RE: Riverside Bikeway | 2900 W Chinden Boulevard
Design Review Resubmittal Narrative | PN: 115154.26

RIVERSIDE HOTEL BIKEWAY

Project No.: 115154.26
Date of Issue: 04.20.2024
Project Milestone: Design Review

C2.03

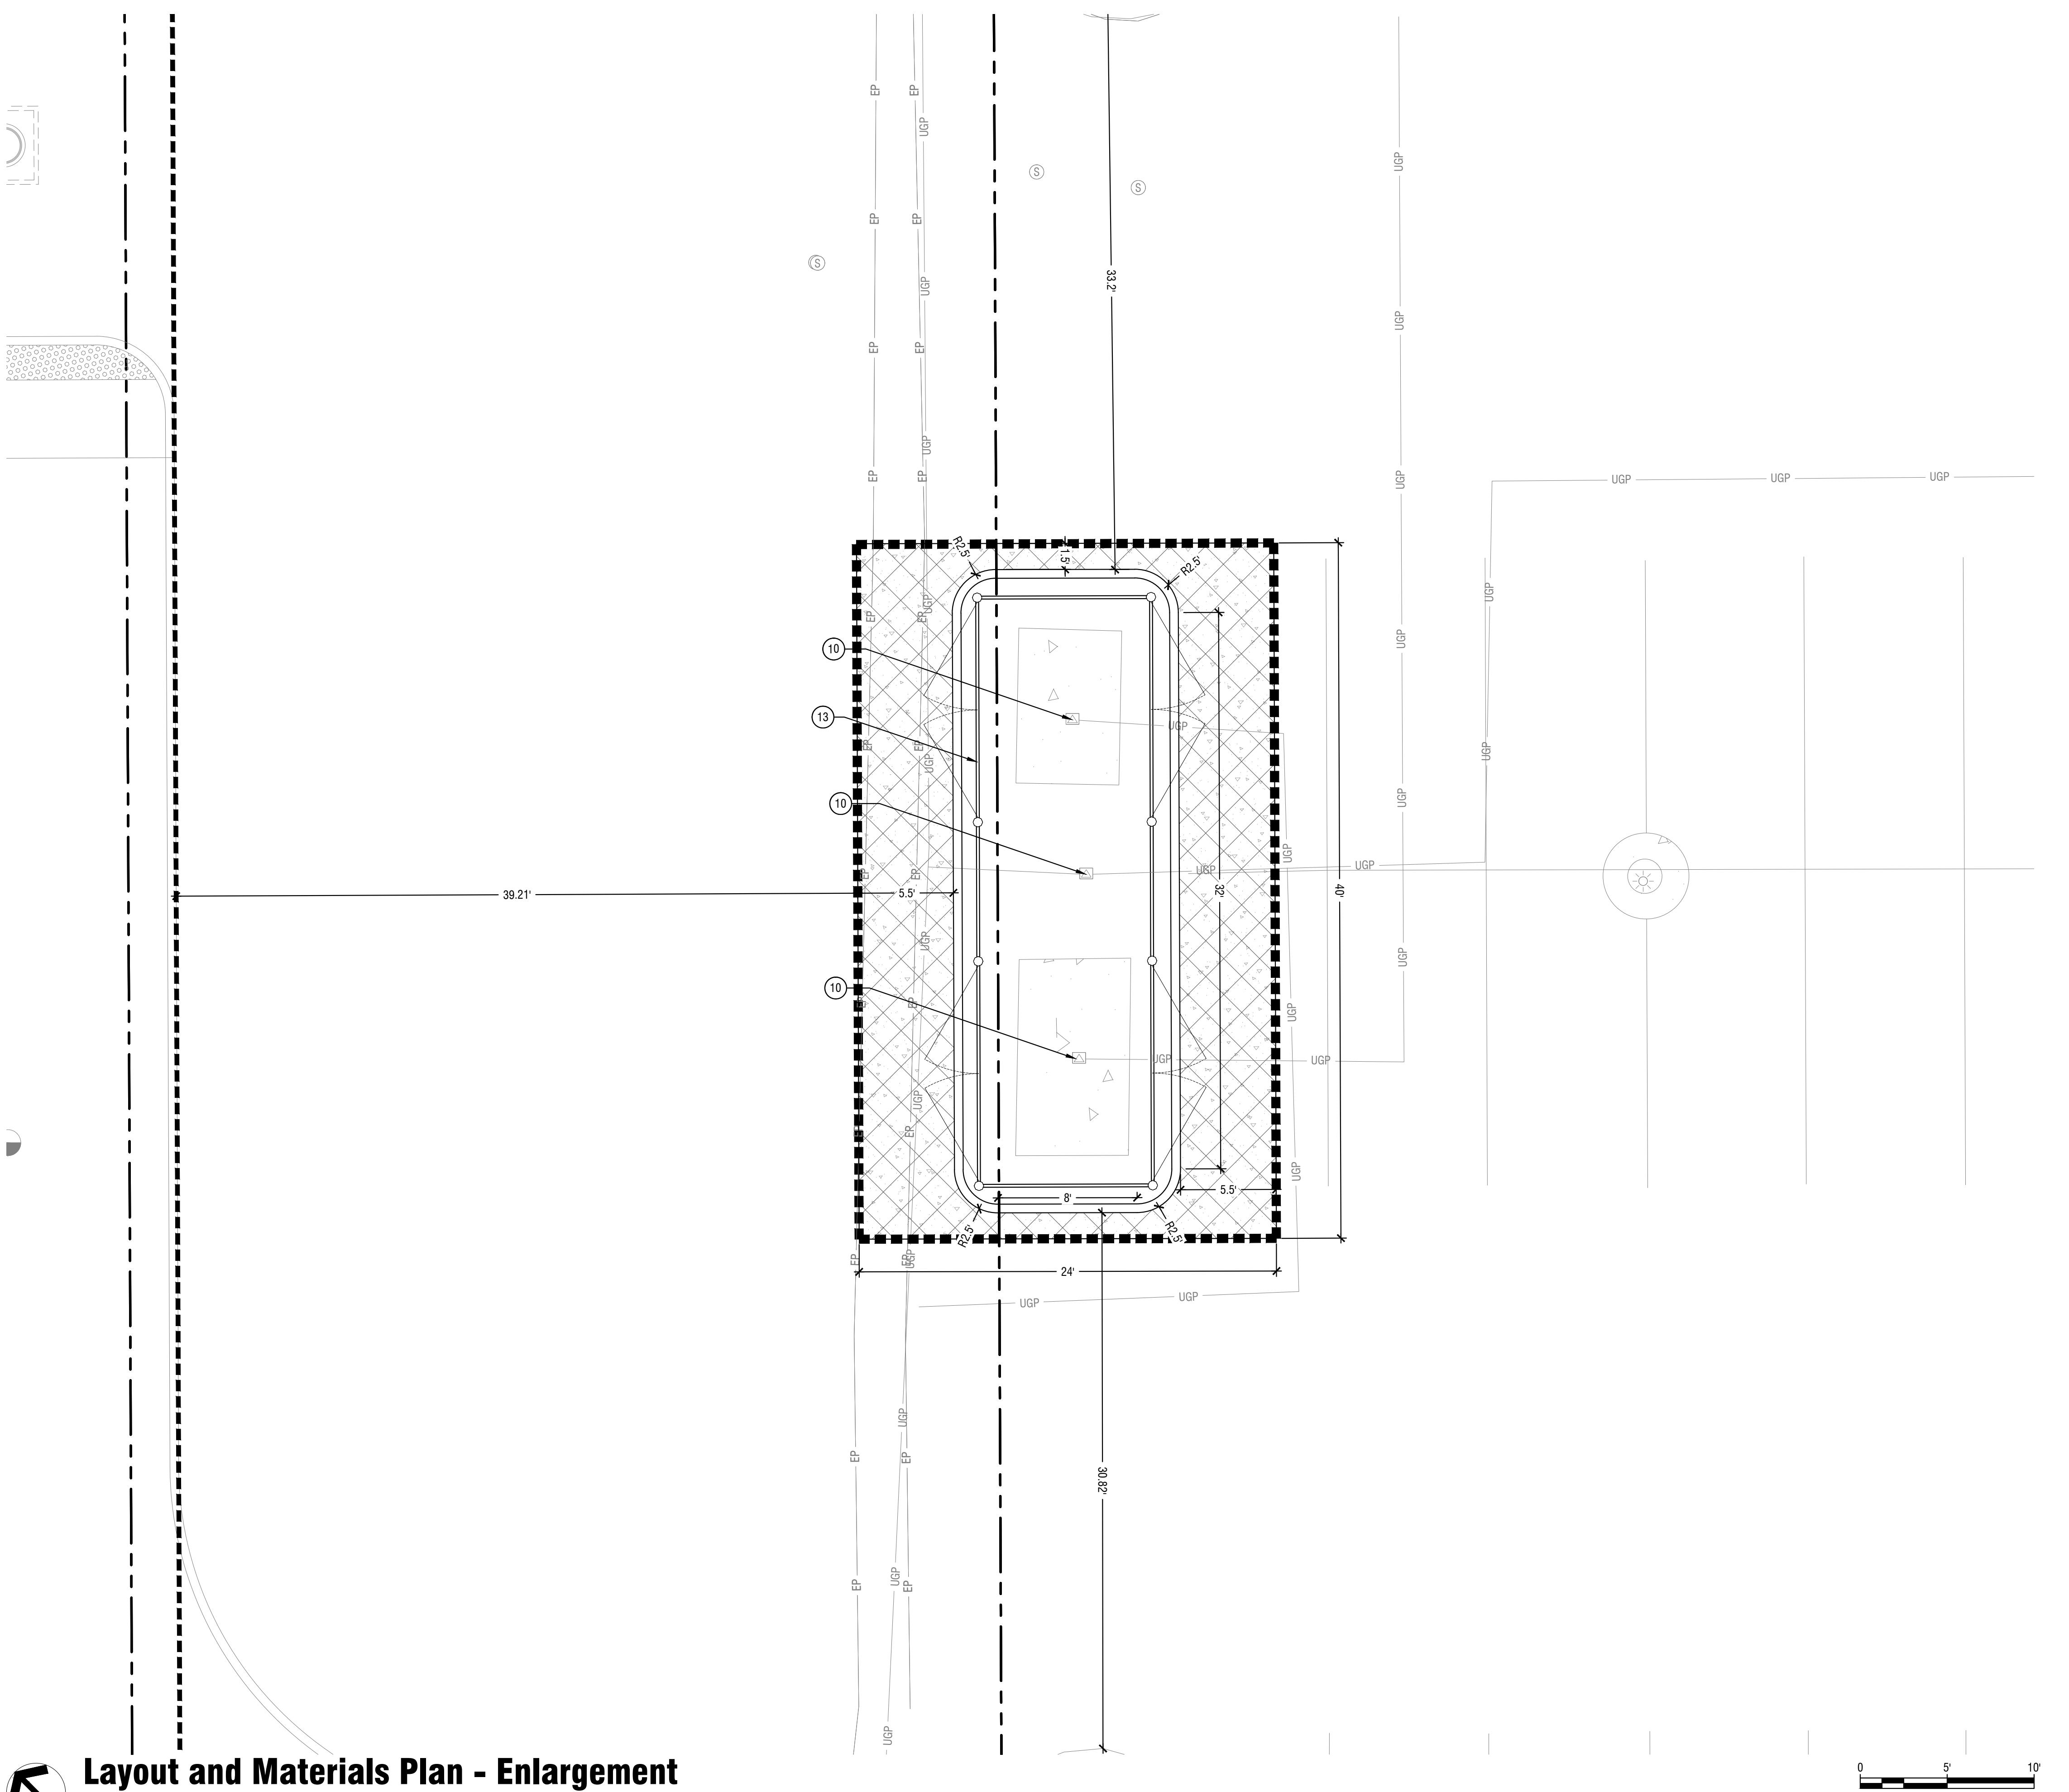
6) "Fences and walls 10"

7) "Curb gutter and sidewalk required along 32nd Street."

- a) **TLG Response:** Please see enclosed drawings. Sheet C2.02 includes a setback dimension; fences and walls of the proposed trash enclosure have been shifted approximately 1.5' east to ensure 10-foot setback from property line at 32nd Street.

Additionally, since ACHD has authority over improvements within the public right-of-way and has declined to require other public right-of-way improvements as part of the application, we have added phasing of sidewalk/pathway improvements as shown on sheet C2.02. This is done to simplify agency review of phase one improvements (i.e. ACHD review timeline will not impact phase one of the project.) Also, it ensures that the Bardenay project's conditions are met in a timely manner. TLG has not heard back from ACHD's 32nd Street project manager (as indicated in the attached email) so flexibility in the final design and arrangement of this public right-of-way phase of work is required at this time to ensure the permitting agency's requirements are adequately addressed at the time of permit drawing submittal.
